Re: Turkey Point Units 3 and 4  
 Docket Nos. 50-250 and 50-251  
 Response to NRC Reactor Systems Branch Request for Additional Information  
 Regarding Extended Power Uprate License Amendment Request No. 205  
 and Thermal Conductivity Degradation

RESPONSE TO NRC SRXB RAI REGARDING EPU LAR NO. 205  
AND THERMAL CONDUCTIVITY DEGRADATION

### Supplement to Updated BELOCA Analysis

**Figure 1 (Figure 5-5 in Reference 4)**  
**PTN IFBA HOTSPOT PCT vs. Effective Break Area**

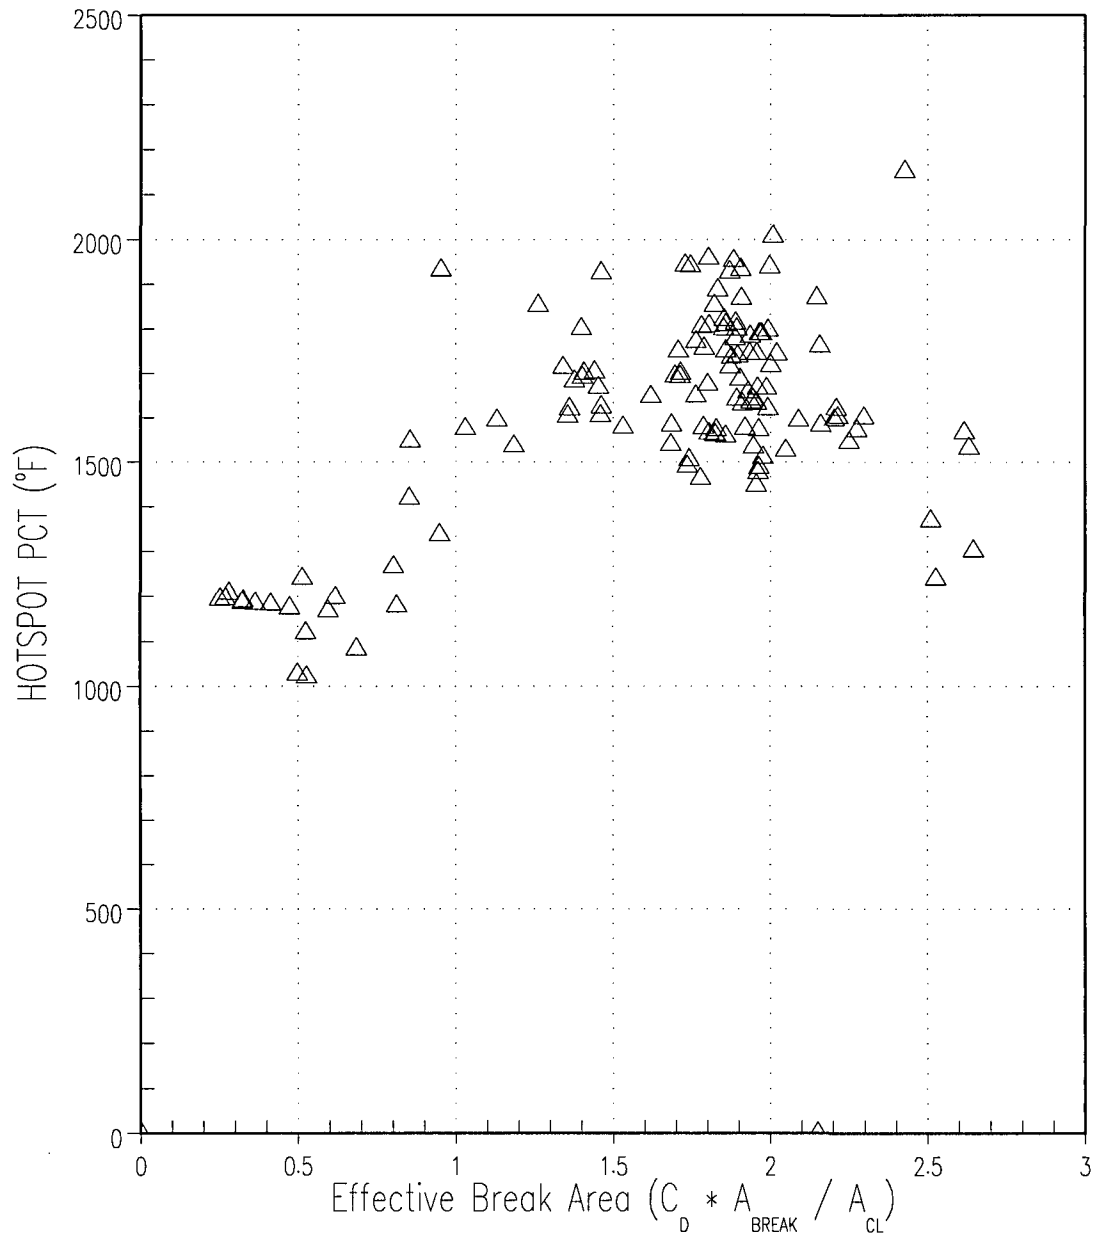
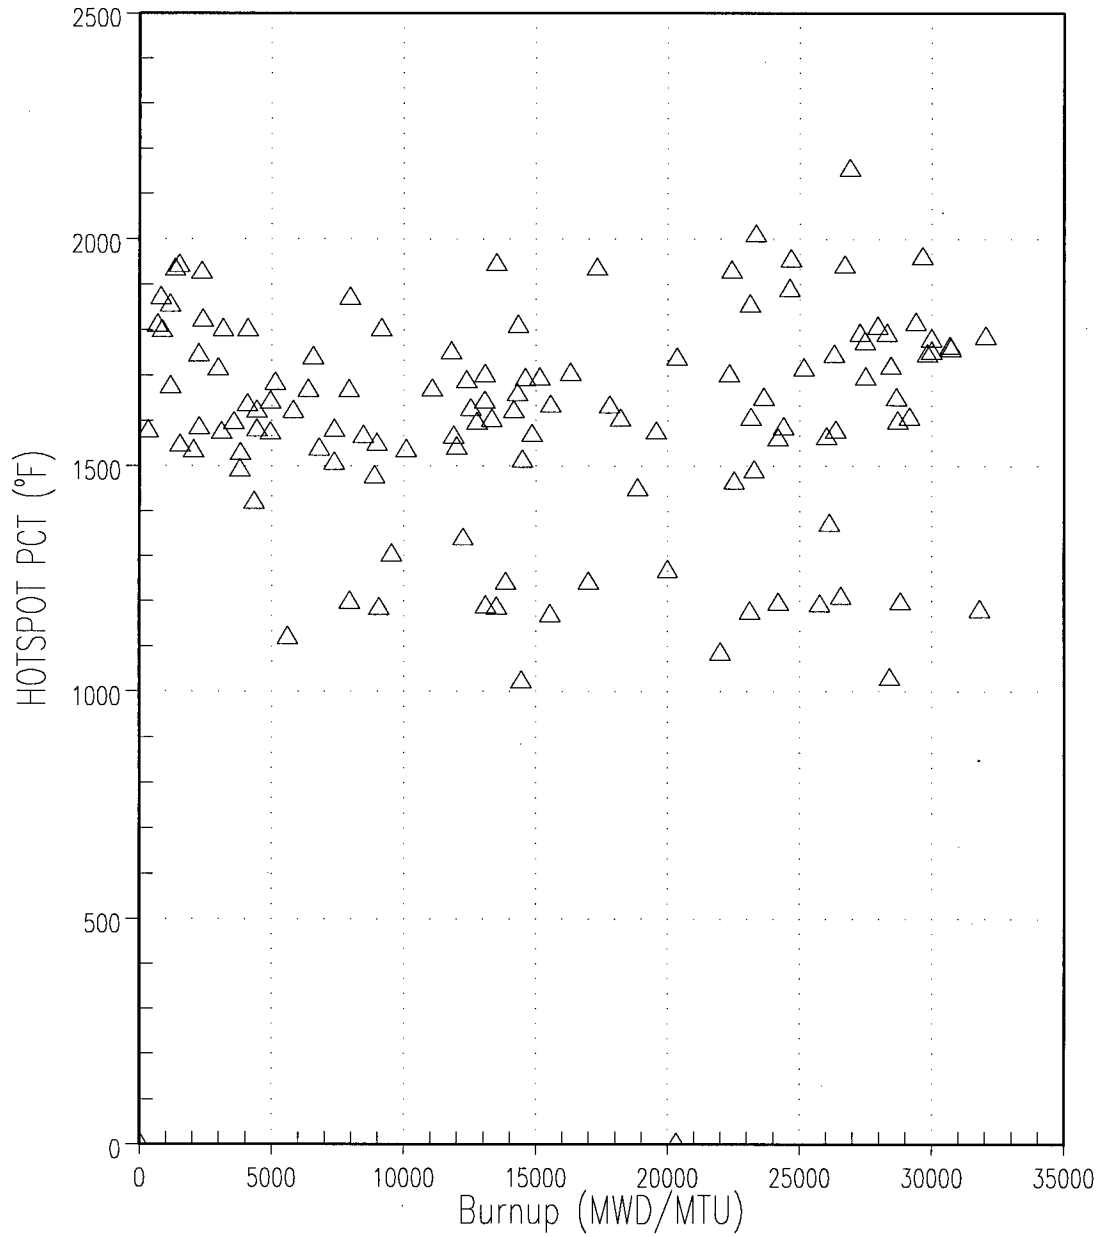
Additionally, IFBA fuel was explicitly evaluated for this updated analysis, which is consistent with the original analysis. Figure 1 shows IFBA HOTSPOT PCT as a function of effective break area and Figure 2 shows IFBA HOTSPOT PCT as a function of hot rod burnup considering the effects of TCD. These figures are analogous to Figures 5-5 and 5-21 of Reference 4.
